Docket No. 50-255
LS05-82- 02-048

SUBJECT: FORWARDING FINAL EVALUATION REPORT OF SEP TOPIC VI-4,
CONTAINMENT ISOLATION SYSTEM FOR THE PALISADES
NUCLEAR POWER PLANT

Containment Systems Branch
Evaluation Report on SEP Topic VI-4,
Containment Isolation System for the
Palisades Nuclear Plant, Unit 1
Docket No. 50-255
Revision 1

Figure 3

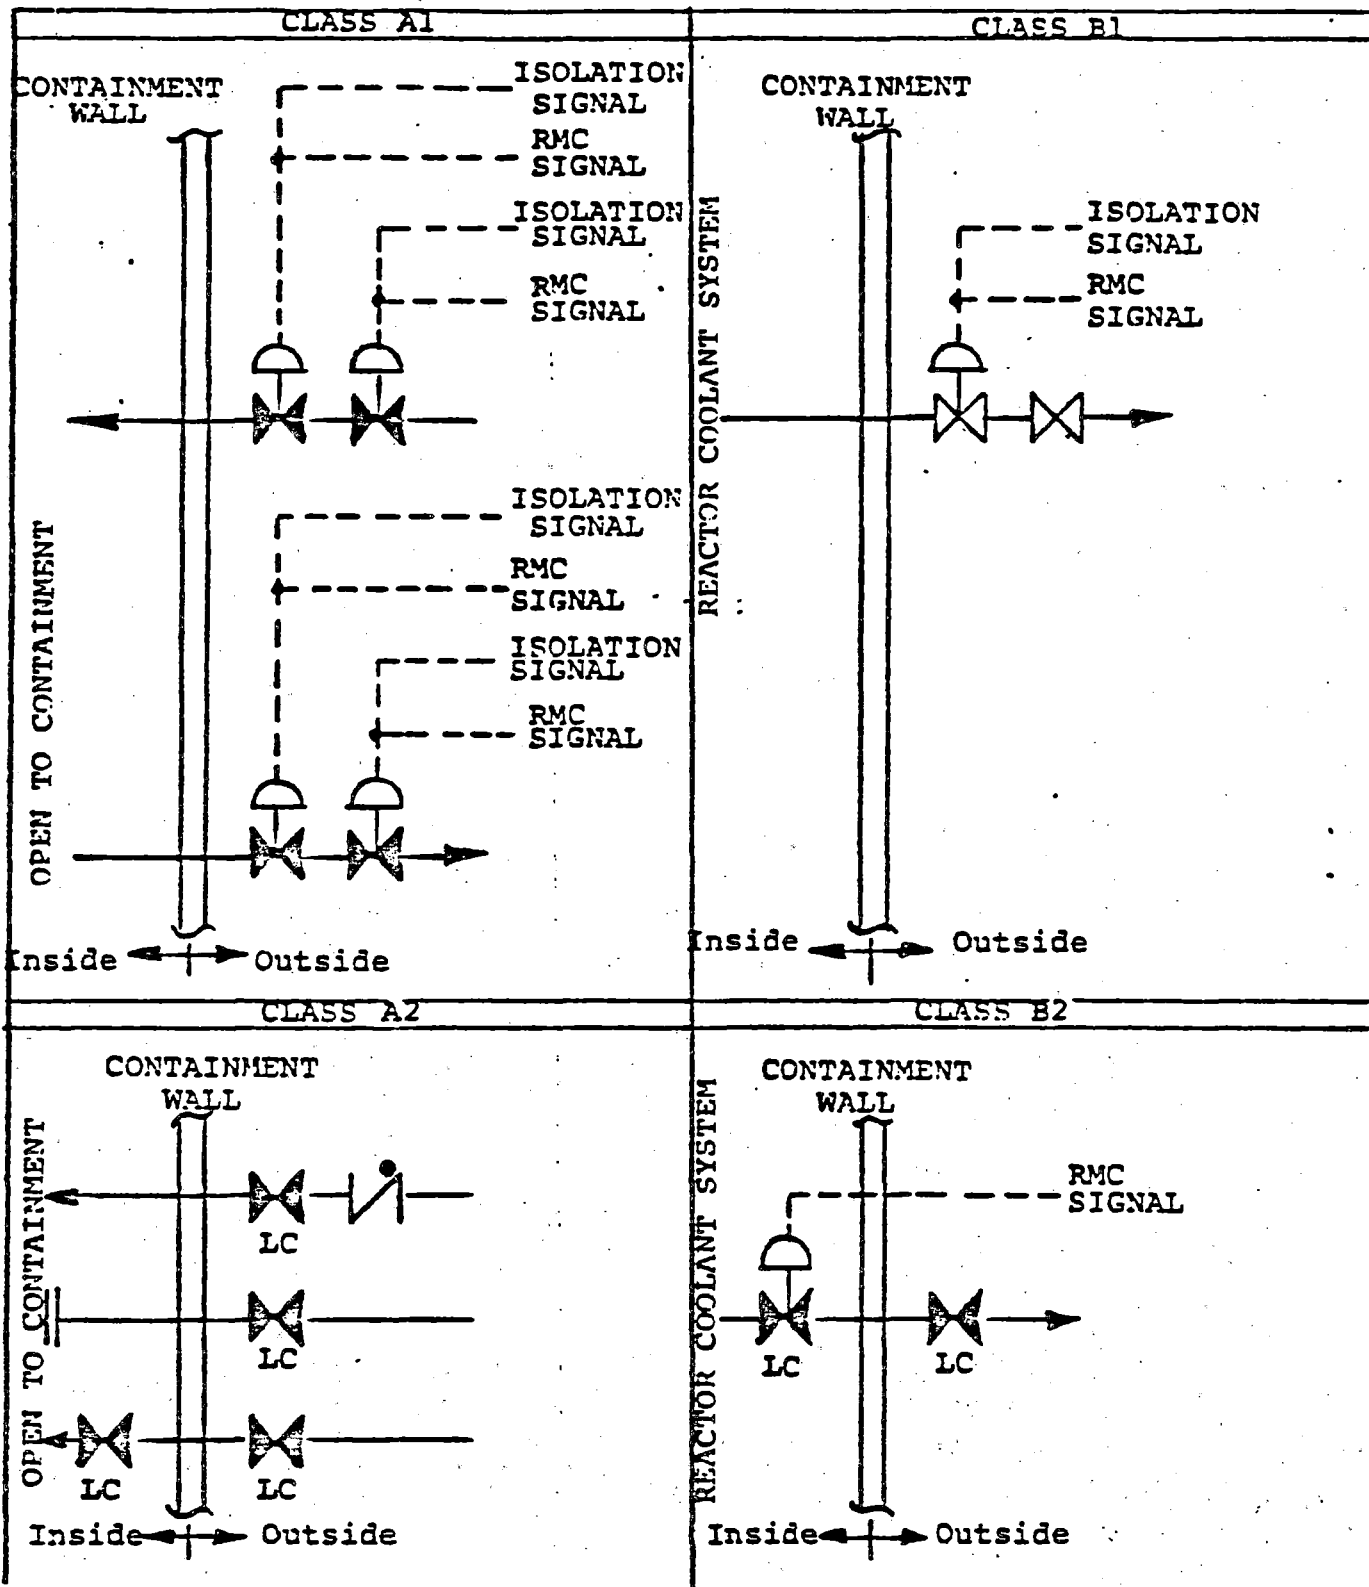
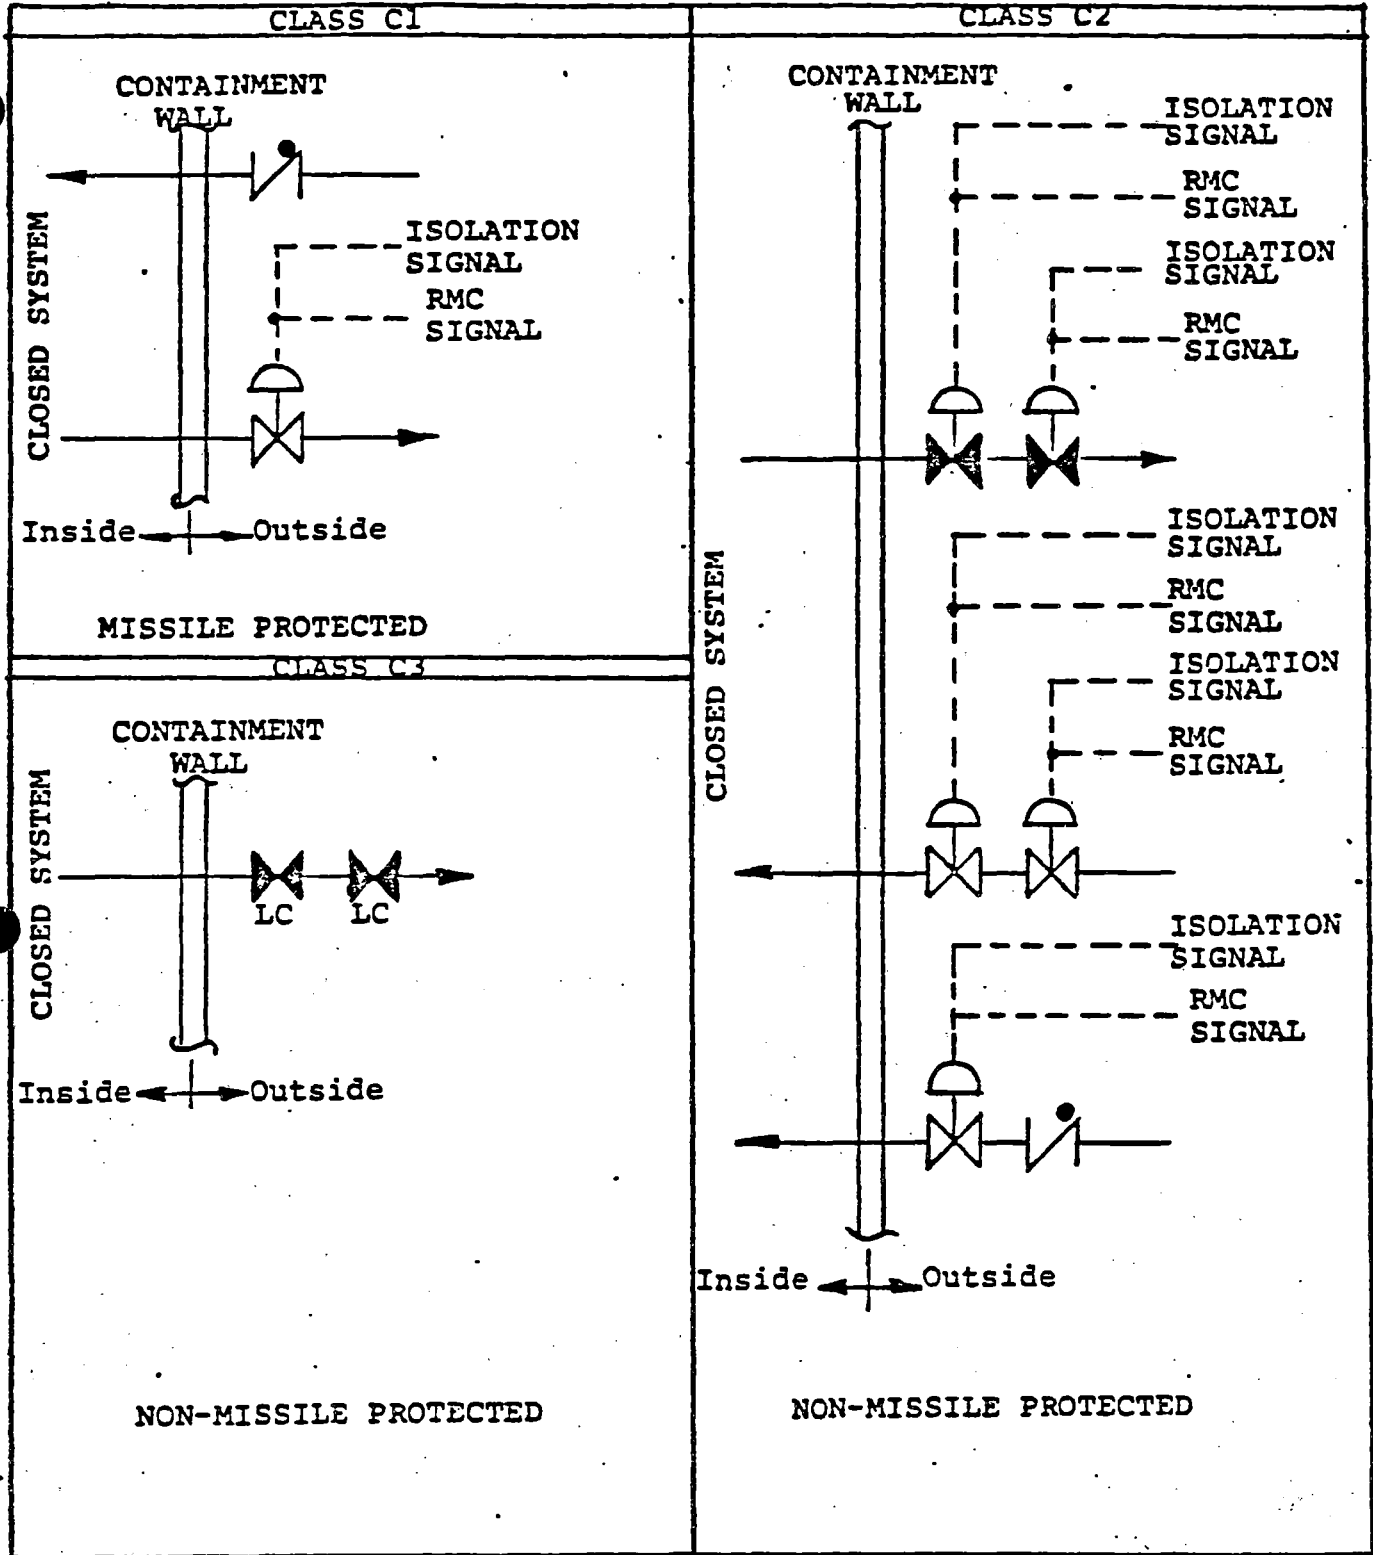
Penetration Class A1 shows influent and effluent lines open to the containment with two isolation valves in series outside containment.

GDC 56 applies to the lines in Penetration Class A1. GDC 56 specifies that one valve should be located inside containment and one valve should be located outside containment. Consequently, the isolation valving arrangement for Penetration Class A1 differs from the explicit requirements of GDC 56 from the standpoint of valve location. Locating both containment isolation valves outside containment may be acceptable if the criteria used in the design of the piping between the containment the first valve are sufficiently conservative to provide adequate assurance of integrity. This matter is discussed under SEP Topic III-1.

Penetration Class A2 shows three isolation configurations that are open to the containment. GDC 56 applies to the lines in Penetration Class A2. One of the isolation configurations (i.e., the line having a locked-closed valve inside containment and a locked-closed valve outside containment) satisfies the explicit requirements of GDC 56. The following containment penetrations have this isolation configuration in Penetration Class A2: 64, 66 and 72.

The isolation configuration having a blind flange inside containment and a locked closed valve outside containment differs from the explicit requirements of GDC 56 from the standpoint of isolation barrier type. GDC 56 does not address the use of blind flanges. However, a blind flange is an acceptable isolation barrier in lieu of a valve. The basis for this appears in SRP 6.2.4 at Item II.3. Also, the locked-closed valve could be an automatic isolation valve and still satisfy GDC 56. The following containment penetrations have this isolation configuration in Penetration Class A2: 18, 18a and 27.

The isolation configuration having both a locked closed valve and a simple check valve outside containment differs from the explicit requirements of GDC 56 from the standpoint of valve location and valve type. GDC 56 specifies that one valve should be located inside containment and one valve should be located outside containment, and that a simple check valve may not be used as an automatic isolation valve outside containment. For this configuration to be acceptable, the check valve should be located inside containment. Also, the locked closed valve could be an automatic isolation valve to satisfy GDC 56.

Penetration Class B1 shows two series isolation valves outside containment in a line coming from the reactor coolant system. As shown, one of the valves is an automatic isolation valve and the other is a normally open, manual valve. Depending on the line, however, a simple check valve or remote manual valve is used. GDC 55 applies to the lines in Penetration Class B1. GDC 55 specifies that one valve should be located inside containment and one valve should be located outside containment, with the valves being either locked closed or automatic isolation valves.

The isolation valving arrangement for Penetration Class B1, therefore, differs from the explicit requirements of GDC 55 from the standpoint of valve location, type, and actuation. Locating both isolation valves outside containment may be acceptable if piping and valve design criteria are sufficiently conservative to preclude a breach of integrity. This matter is

Penetration Class B2 shows a locked closed valve inside containment and a locked closed valve outside containment in a reactor coolant system effluent line. GDC 55 applies to the lines in Penetration Class B2. The isolation arrangement satisfies the explicit requirements of GDC 55.

Penetration Class C1 shows two types of valve arrangements for closed systems inside containment that are missile protected; namely, a single simple check valve outside containment for influent lines and a single automatic isolation valve outside containment for effluent lines. GDC 57 applies to the lines in Penetration Class C1. GDC 57 specifies that a single automatic, remote manual or locked closed isolation valve outside containment is acceptable, but a simple check valve is not an acceptable automatic isolation valve. The isolation valve arrangement having a

single simple check valve outside containment differs from the explicit requirements of GDC 57 from the standpoint of valve type.

Penetration Class C2 shows isolation valve arrangements for influent and effluent lines of closed systems inside containment that are not missile protected. The valve arrangements consist of two valves in series, outside containment.

GDC 56 applies to the lines in Penetration Class C2. GDC 56 specifies that one automatic or locked closed valve should be located inside containment and one such valve should be located outside containment; also, a simple check valve may not be used as an automatic isolation valve outside containment.

The valve arrangements of Penetration Class C2 differ from the explicit requirements of GDC 56 from the standpoint of valve location and valve type. All valve arrangements would satisfy the explicit requirements of GDC 56 if one valve was located inside containment, particularly the simple check valve.

GDC 56 permits isolation valve arrangements that differ from the explicit requirements provided the basis for acceptability is defined. With respect to Penetration Class C2, then, locating both isolation valves outside containment may be acceptable since missile protection is not provided inside containment. The acceptability of this is contingent on the criteria used in the design of the piping between the containment and first valve, and the first valve, which must provide adequate assurance of integrity.

Penetration Class C3 shows two, locked closed isolation valves in series, outside containment, for effluent lines from systems that are closed inside containment and not missile protected. GDC 56 applies to the lines in Penetration Class C3. The valve arrangements described above differs from the explicit requirements of GDC 56 from the standpoint of valve location, namely, one valve should be located inside containment. However, locating both valves outside containment may be acceptable, based on the discussion under Penetration Class C2.

discussed under SEP Topic III-1. The use of a local manual valve for containment isolation is not acceptable, and should be upgraded to an automatic isolation valve.

For penetrations 11, 14, 26, 27, 41, 42 and 67, the simple check valve is not an appropriate automatic isolation valve outside containment. A power operated automatic isolation valve would be acceptable. However, a judgment decision regarding the acceptability of the simple check valve will be made at the time of the integrated assessment of the plant.

Penetration 25 shows a capped test connection which should be equipped with two locked closed isolation valves in series. Penetration 44 shows a manual isolation valve (3/4"-2084) which is not depicted by the isolation valve arrangements of Penetration Class C2, and which differs from the explicit requirements of GDC 56 from the standpoint of valve actuation; the subject valve should be a power operated valve that is automatically actuated.

Figure 3

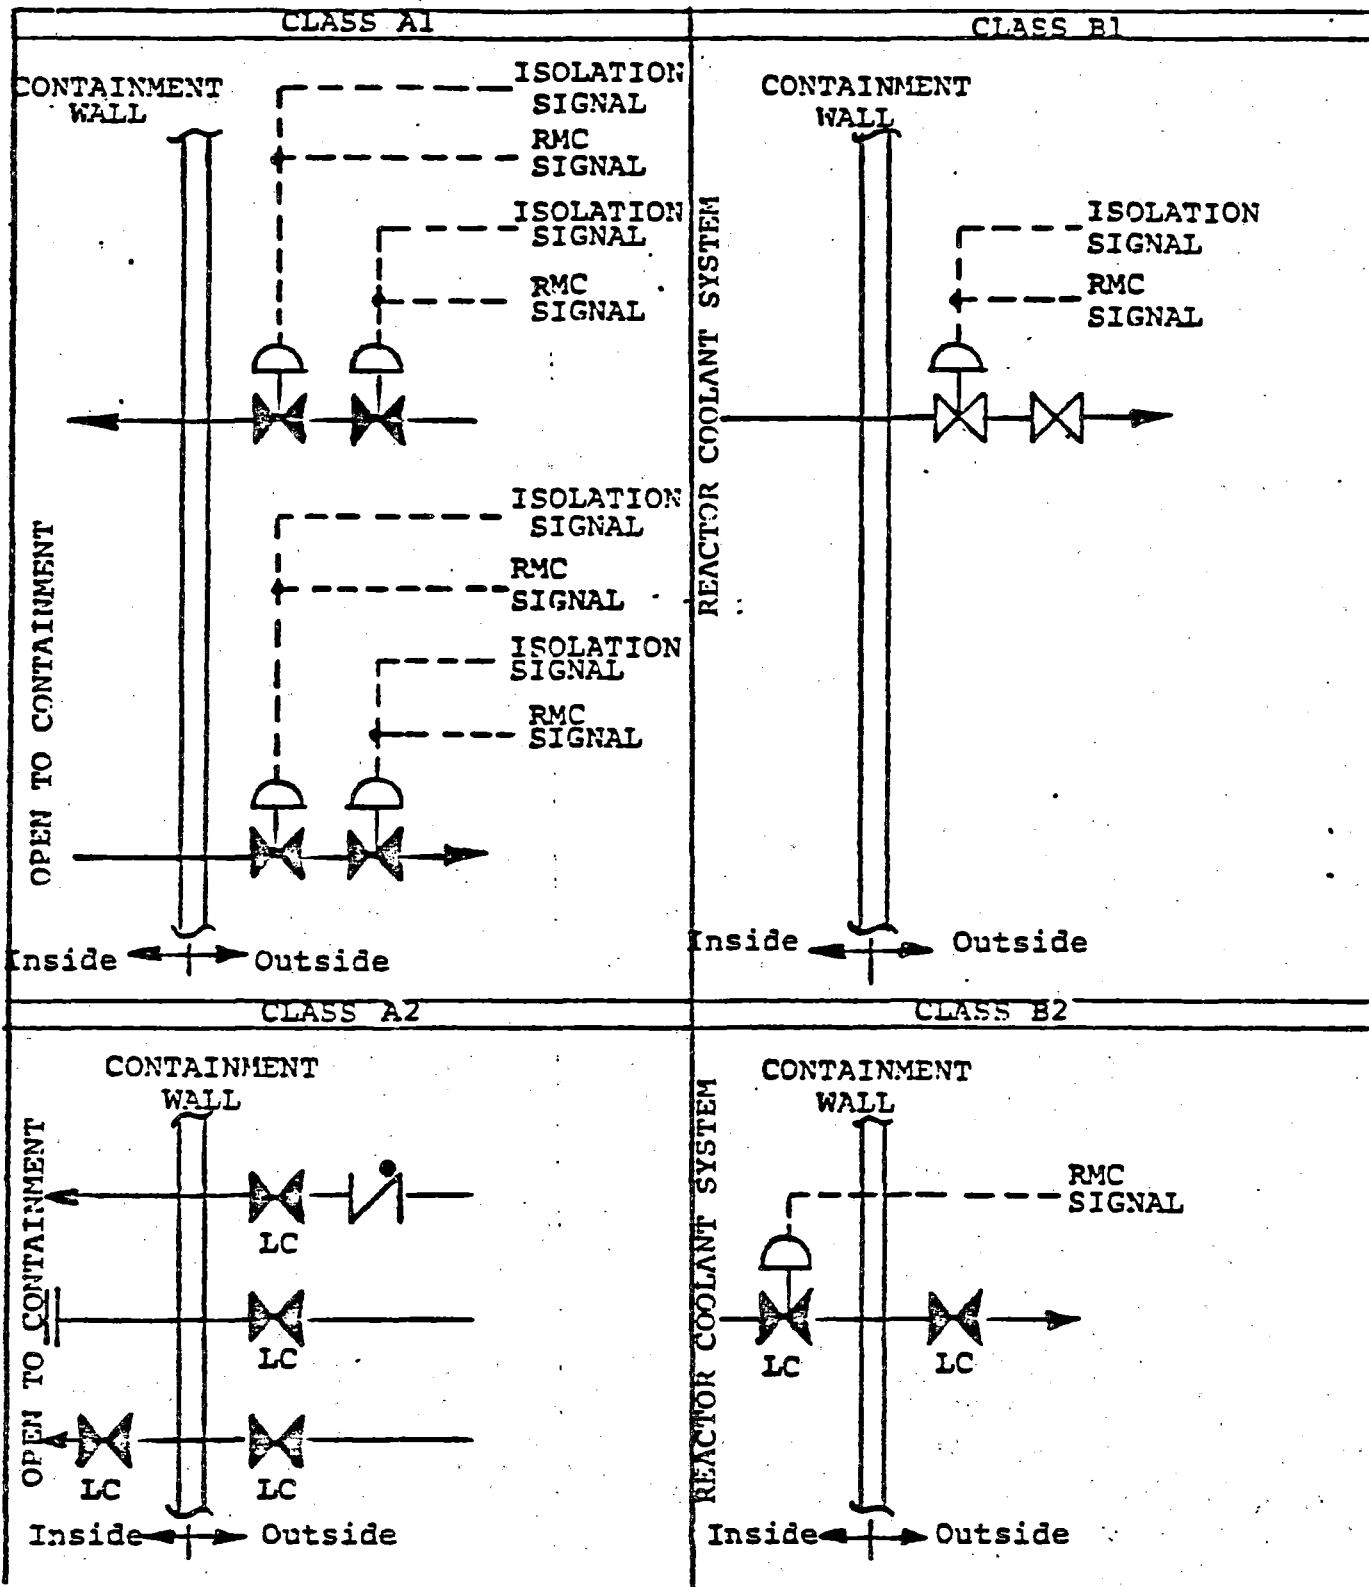
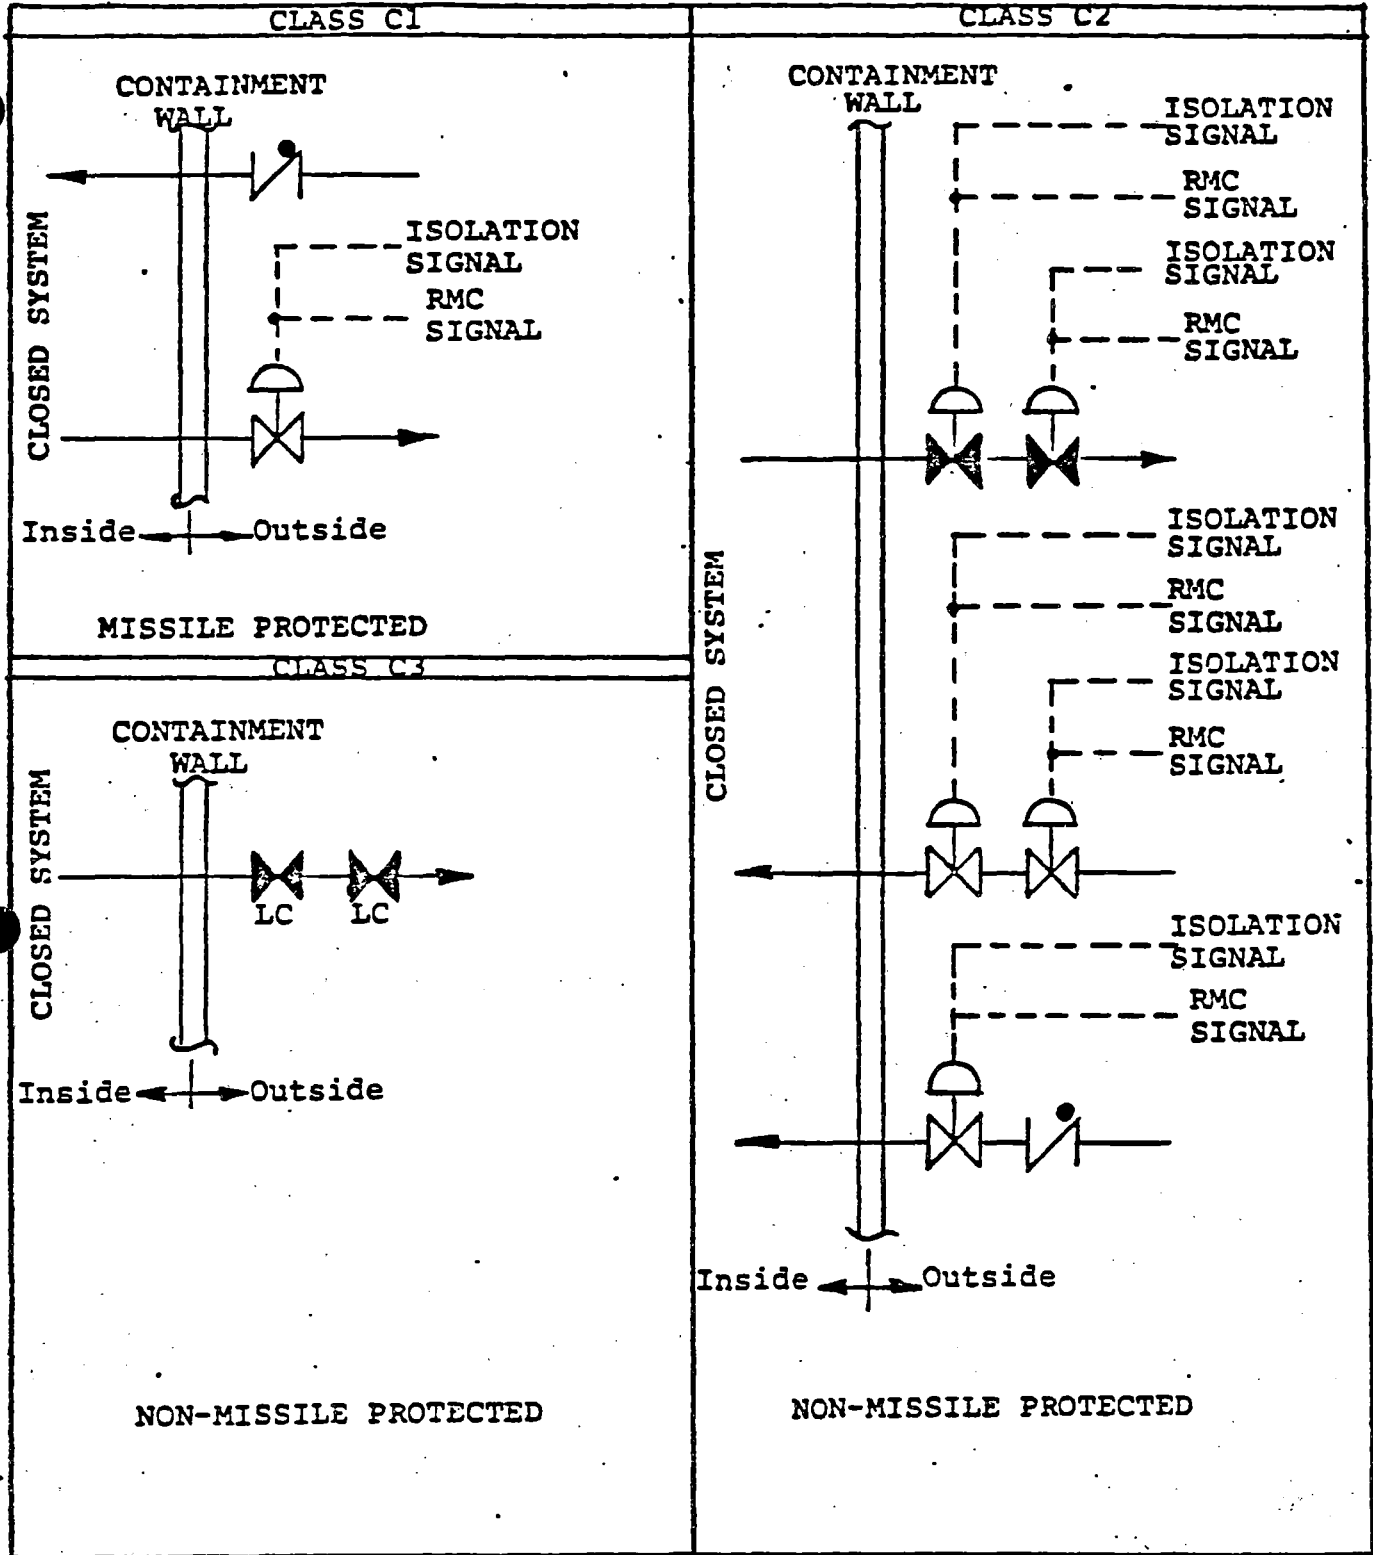
GDC 56 applies to the lines in Penetration Class A1. GDC 56 specifies that one valve should be located inside containment and one valve should be located outside containment. Consequently, the isolation valving arrangement for Penetration Class A1 differs from the explicit requirements of GDC 56 from the standpoint of valve location. Locating both containment isolation valves outside containment may be acceptable if the criteria used in the design of the piping between the containment the first valve are sufficiently conservative to provide adequate assurance of integrity. This matter is discussed under SEP Topic III-1.

The following containment penetrations have the above isolation configuration in Penetration Class A2: 10 and 65. A judgment regarding the acceptability of the simple check valve outside containment as a bonafide containment isolation valve will be made in conjunction with the integrated assessment of the plant.

GDC 56 permits isolation valve arrangements that differ from the explicit requirements provided the basis for acceptability is defined. With respect to Penetration Class C2, then, locating both isolation valves outside containment may be acceptable since missile protection is not provided inside containment. The acceptability of this is contingent on the criteria used in the design of the piping between the containment and first valve, and the first valve, which must provide adequate assurance of integrity.

For penetrations 11, 14, 26, 27, 41, 42 and 67, the simple check valve is not an appropriate automatic isolation valve outside containment. A power operated automatic isolation valve would be acceptable. However, a judgment decision regarding the acceptability of the simple check valve will be made at the time of the integrated assessment of the plant.
